Project	IEEE 802.16 Broadband Wireless Access Working Group < http://ieee802.org/16 >	
Title	4-antenna MIMO pilot allocation for PUSC	
Date Submitted	2005-01-13	
Source:	Jianglei Ma, Peiyong Zhu, Wen Tong, Ming Jia, Mo-Han Fong, Hang Zhang, Brian Johnson Nortel Networks 3500 Carling Avenue Ottawa, ON. K2H 8E9 CANADA	Voice: (613)-765-8089 Fax: (613)-765-7723 pyzhu@nortelnetworks.com
Re:	Call for Reply Comments regarding the Maintenance Task Group Comment Report 80216maint-04_09.zip	
Abstract	In this contribution, we propose to clarify the 4-antenna MIMO pilot allocation for PUSC	
Purpose	The contribution should be considered by Maintenance group within comment resolution procedure	
Notice	This document has been prepared to assist IEEE 802.16. It is offered as a basis for discussion and is not binding on the contributing individual(s) or organization(s). The material in this document is subject to change in form and content after further study. The contributor(s) reserve(s) the right to add, amend or withdraw material contained herein.

4-antenna MIMO pilot allocation for PUSC

Figure 251 –Cluster Structure

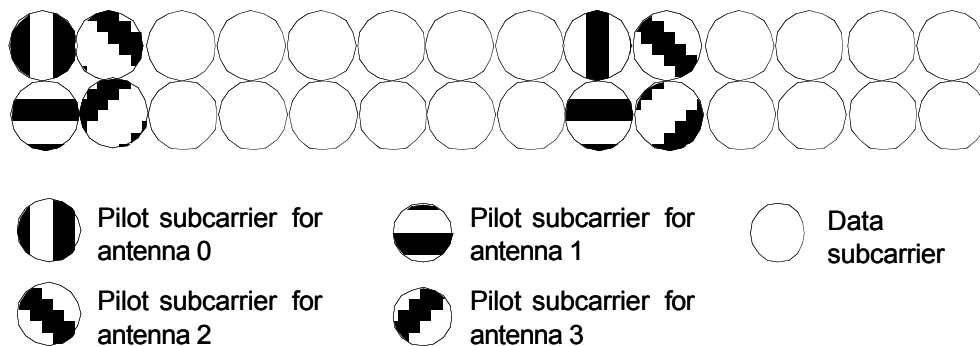
~~For~~ For this configuration the basic cluster structure is changed as indicated in Figure 251 to accommodate the transmission from 4 antennas (pilots for antennas 2/3 override data subcarriers ~~in the even symbols, switching and erasing of the data subcarriers shall be performed after constellation mapping, therefore maintaining all the encoding scheme and the subchannel allocation scheme~~).

Change Figure 251 in section 8.4.8.2.1

The pilot locations in PUSC cluster shall obey the following rule:

$PilotsLocation = PUSC_Pilot_Location + 4 \cdot (\text{floor}(PUSC_SymbolNumber/2) \bmod 2)$
 where PUSC_SymbolNumber counts from 0 at the starting of the relevant STC zone. PUSC_Pilot_Location = 0,1, 8,9 is the frequency offset of the pilot carriers in each cluster.
